Vermont Agency of Transportation
RECEIVED
 ON: March 21, 2016
 and Checked for
CONFORMANCE
 BY: ABC DATE:

| REV. | DATE | REMARKS | DWN | CHK | APVL | SHOP |
|--|------|---|--------|----------|-------------|------|
| DESCRIPTION: BOTTOM CHORDS | | | | | | |
| TH-10 OVER OTTER CREEK PONY TRUSS BRIDGE | | RB | | 12/15/15 | | |
| RUTLAND CITY, VERMONT | | 598 | | 2 | | |

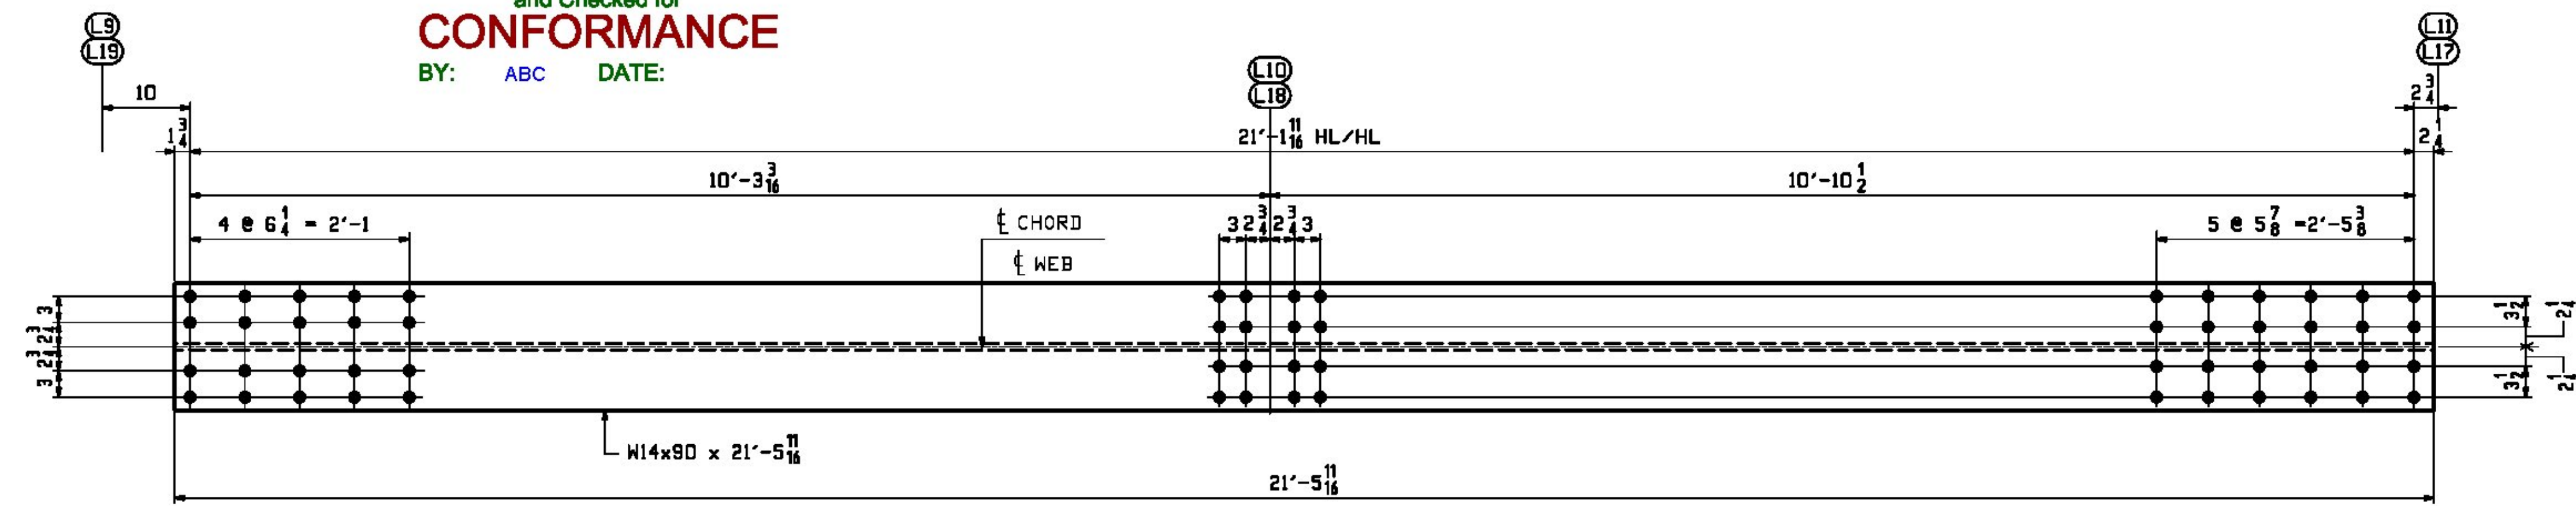
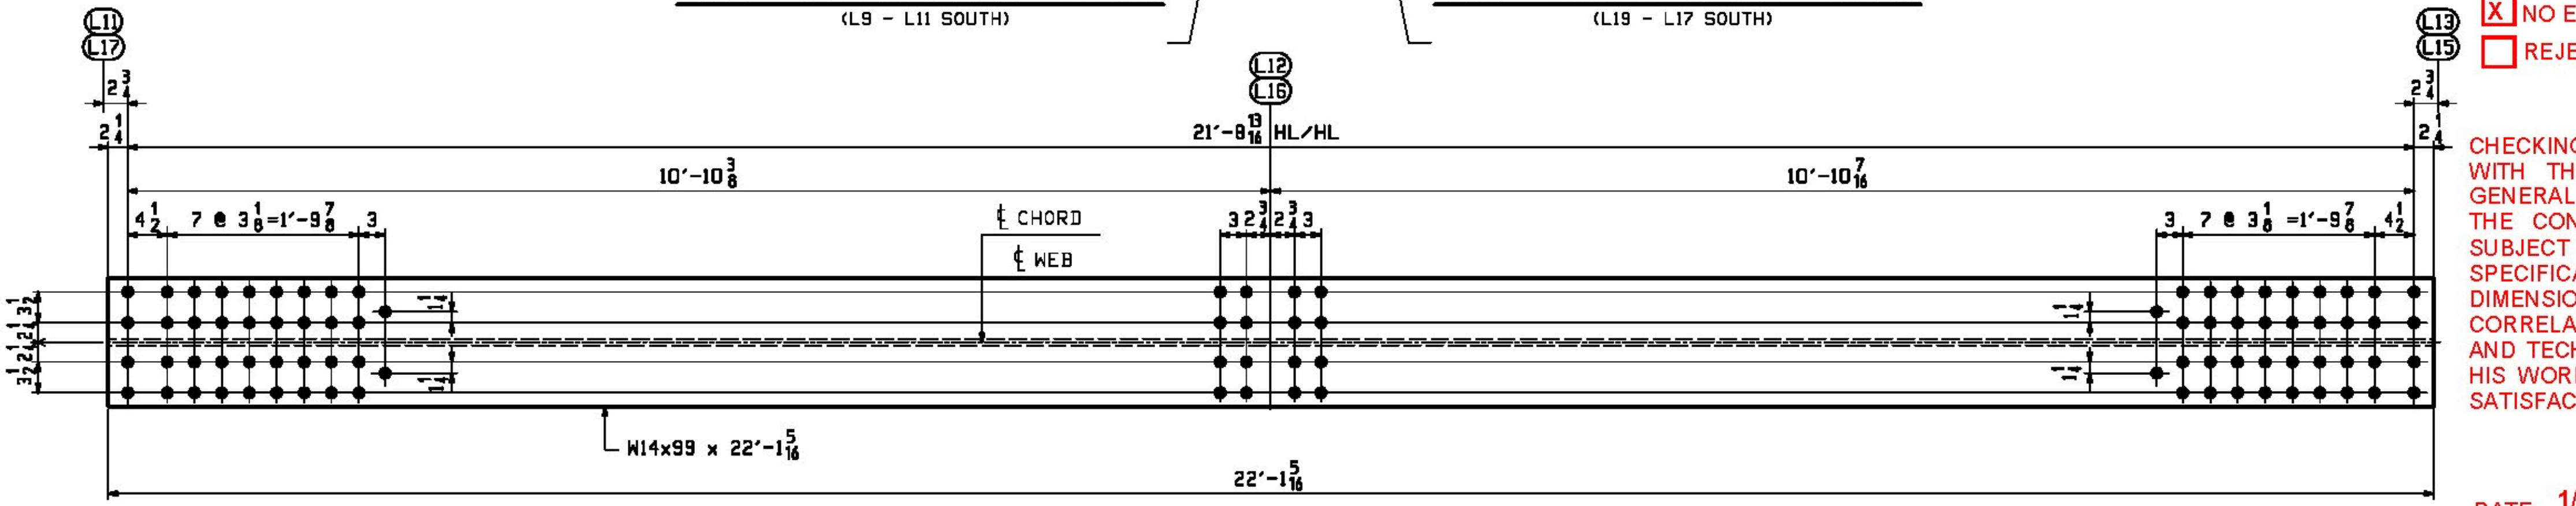
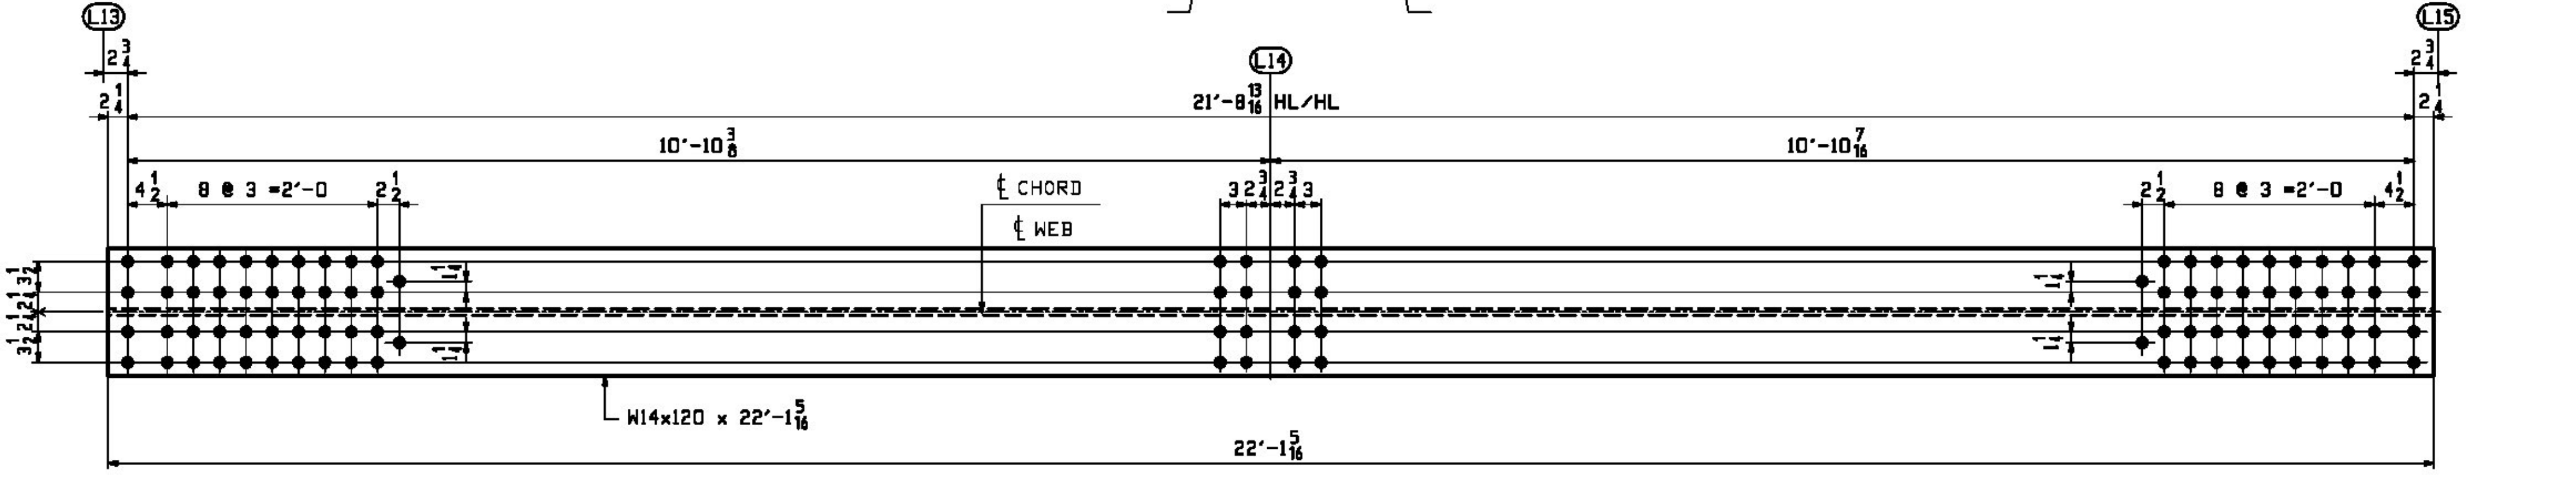
ALL STEEL SHALL BE HOT DIP GALVANIZED ACCORDANCE WITH SUBSECTION 506.15.
